Zoning & Subdivision Committee

Thursday, September 12, 2019

Staff Report – Eversole Run Neighborhood Section 2 Phase 1

**Subject: Eversole Run Neighborhood, Section 2 Phase 1, Amended
Final Plat Review – Comment Letter #2**

EVERSOLE RUN NEIGHBORHOOD SECTION 2 PHASE 1 AMENDED

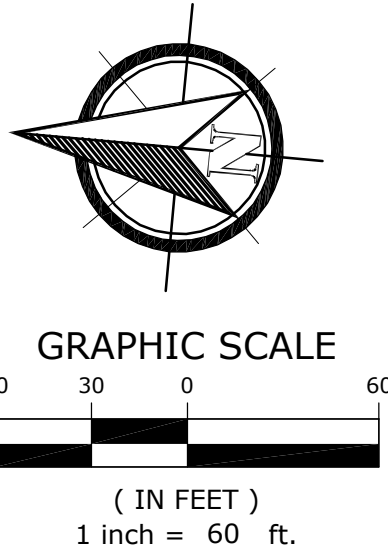
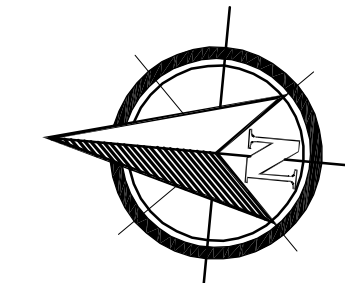
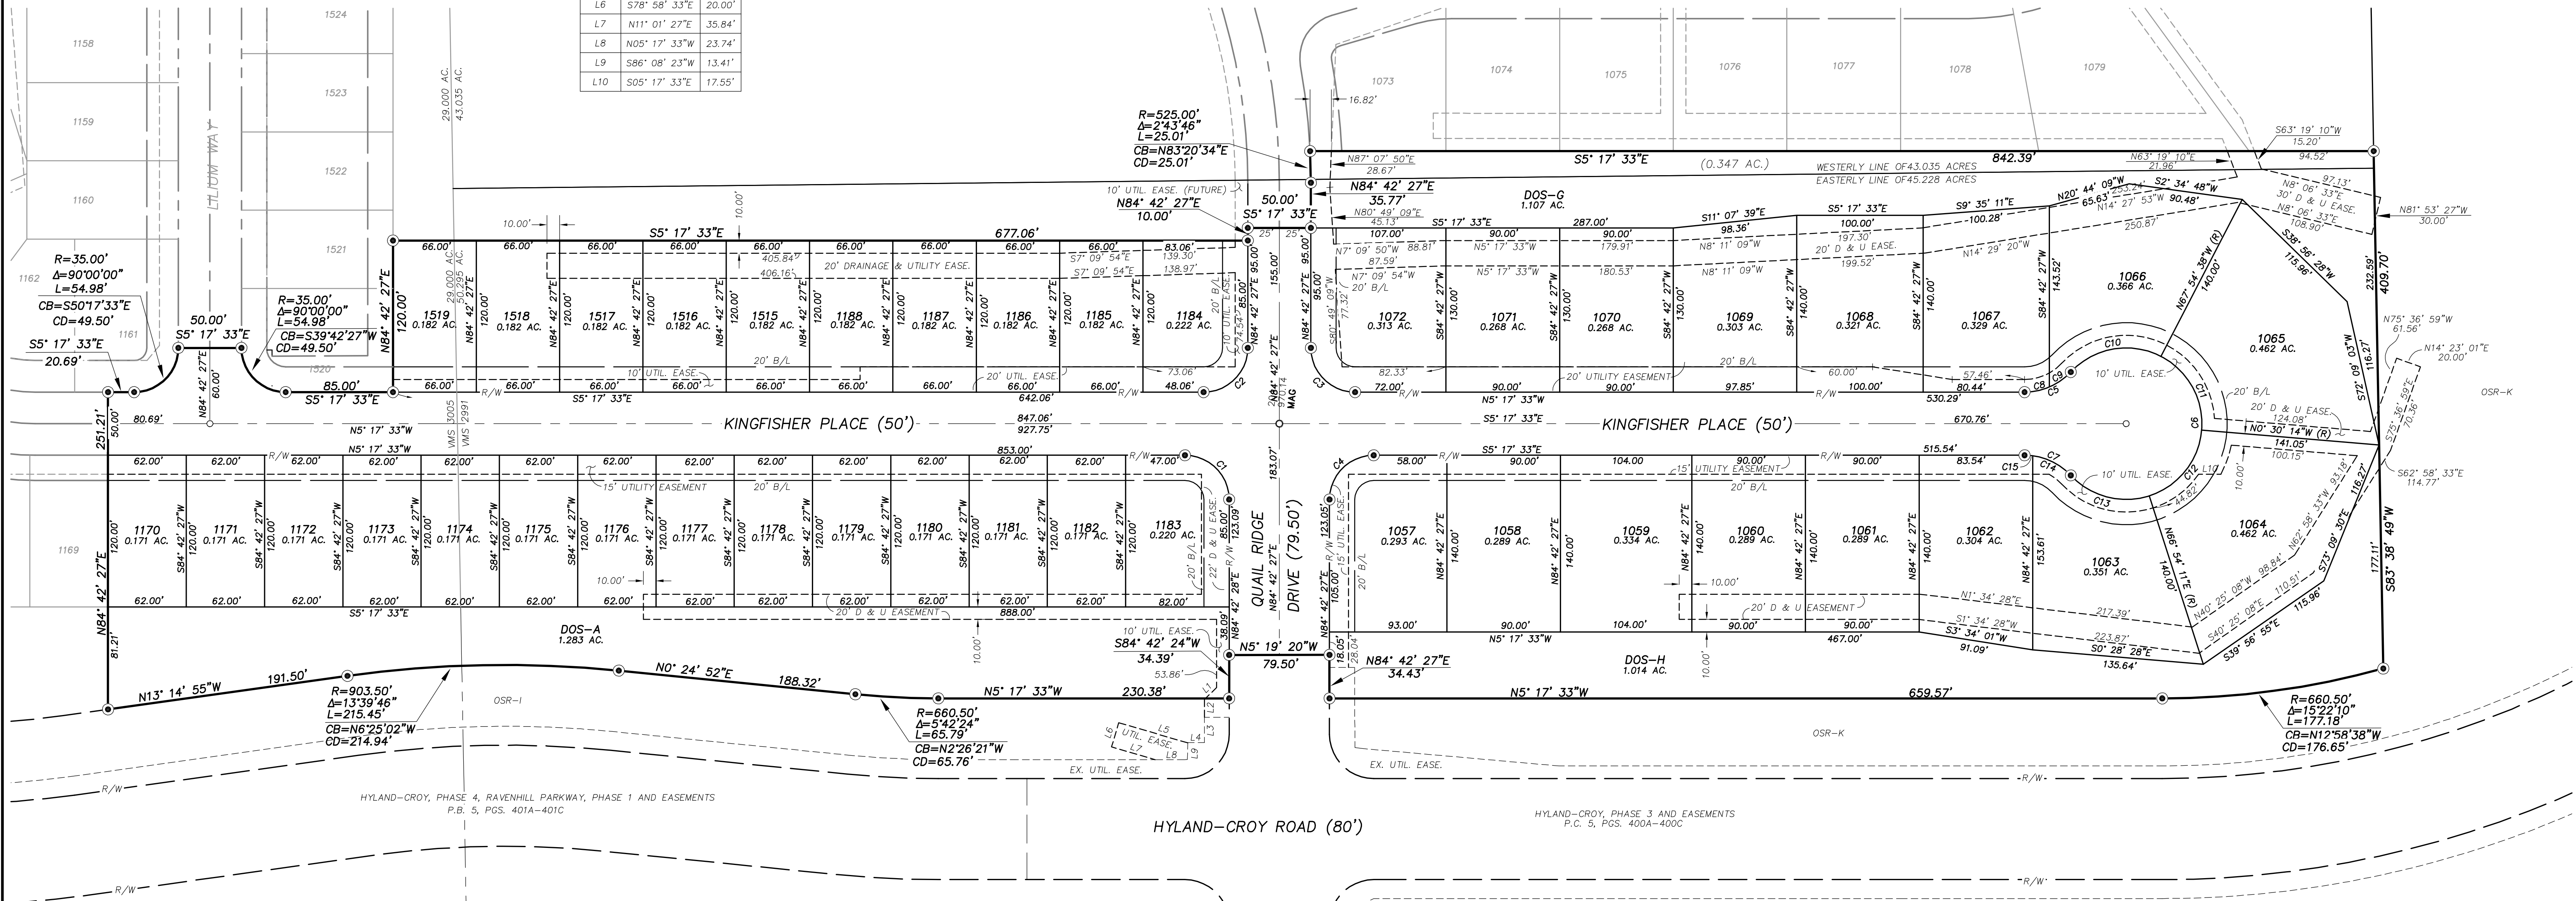
1. Sheet 1: Please verify/update the note for Open Space; it references The Courtyards at Jerome Village (§313, 16.).
2. Sheet 1: Please show zoning of adjoining properties (§313, 9.).
3. Sheet 4: Please verify/update lot numbers of 14, 15, 85, 86. They show as 117, 118, 119, 120 (§313, 6.).
4. Label easements and widths. Easements for water and sewer must be a minimum for 20' and 10' for other utilities (§313, 12.; §414).
5. All variances or exceptions shall be approved by the County Commissioners before any action by the

NEW CALIFORNIA HILLS XIII
PRELIMINARY PLAT
SITE PLAN

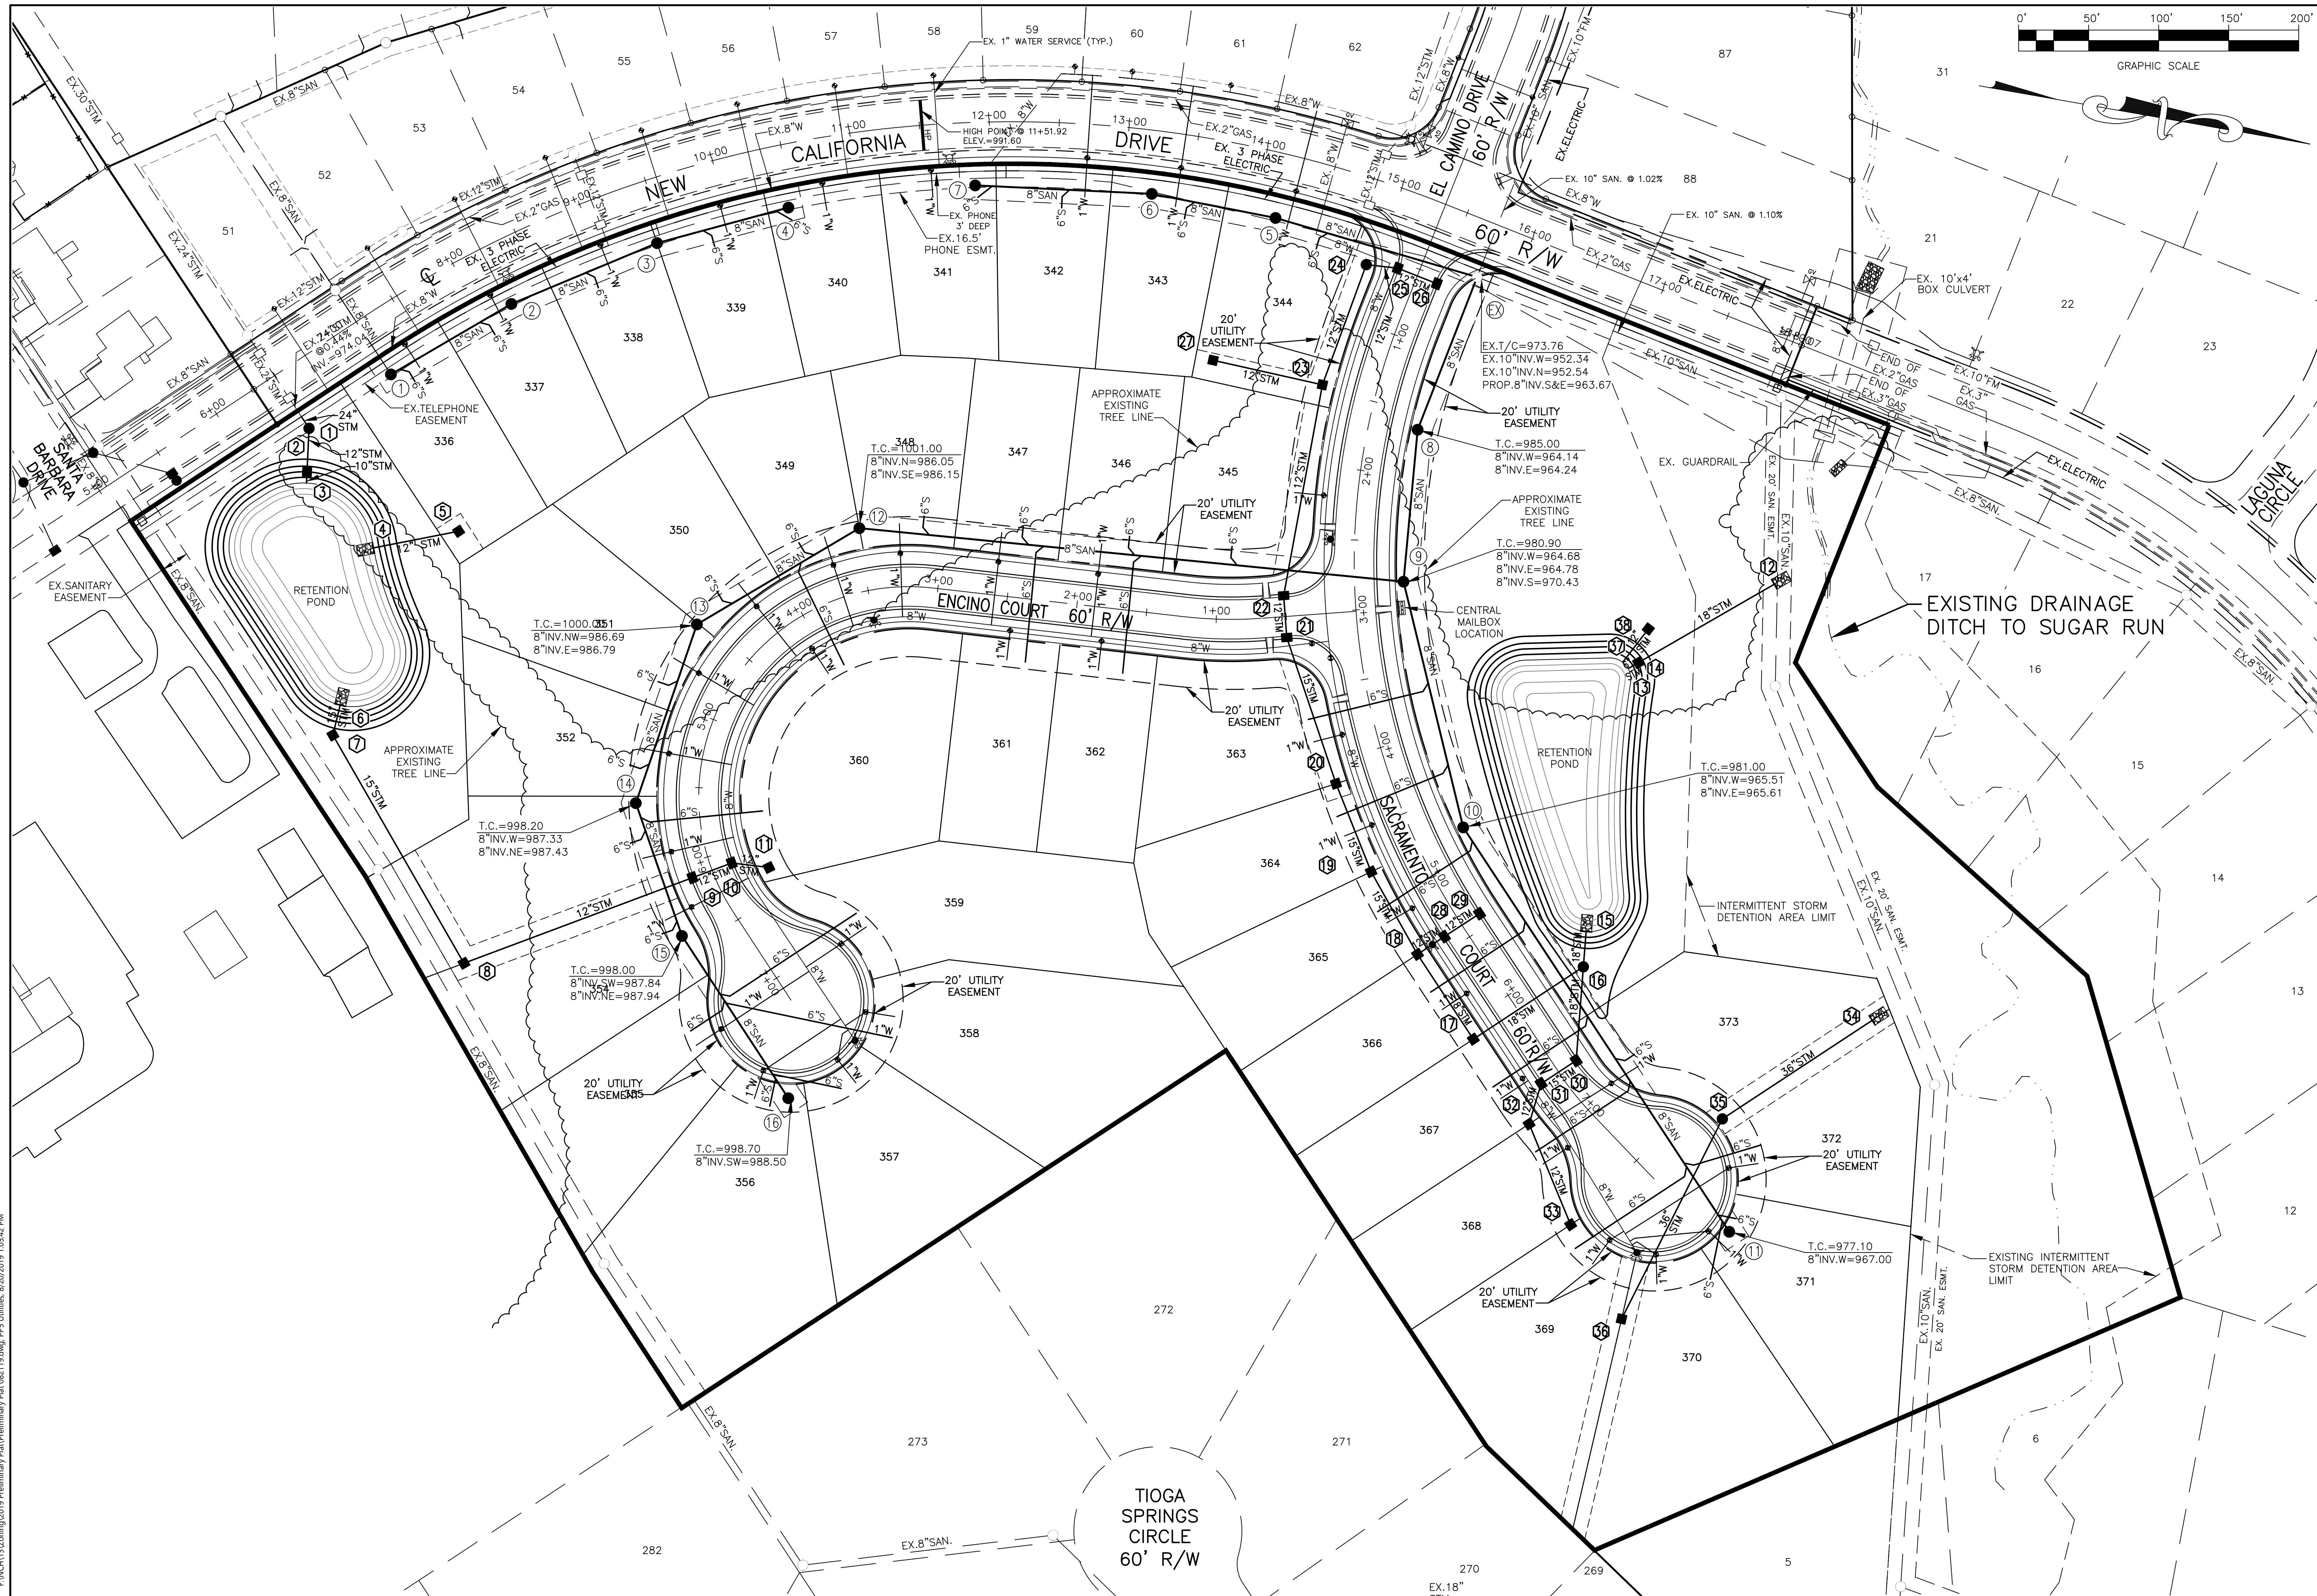
- 4) Sheet 4 of 10 – Preliminary Plat
 - a) No comments
- 5) Sheet 5 of 10 – Preliminary Plat
 - a) 38 residential lots (lots 336-373)
 - b) URE proposes additional 10' easement in front of park/open space parallel to New California Drive. (1.103 acres)

- c) URE proposes additional 20' easement along the south side of lot 336 and open space/park. (1.103 acres)
 - d) URE proposes rear lot easements from lot 352-345, 336-344.

- e) URE proposes additional 10' easement parallel to New California Drive in the park. (4.438 acres)
 - f) URE proposes additional 10' easement along Sacramento Court to lot 373

- g) URE proposes additional 10' easement from lot 373 to lot 363.
 - h) URE proposes additional 10' easement parallel to Sacramento Court along lot 345.

- i) URE proposes additional 10' easement along lots 356-352.
 - j) URE proposes additional 20' side lot easement between lot 351-352.
 - k) Need to define the noted utility easements for clarity.
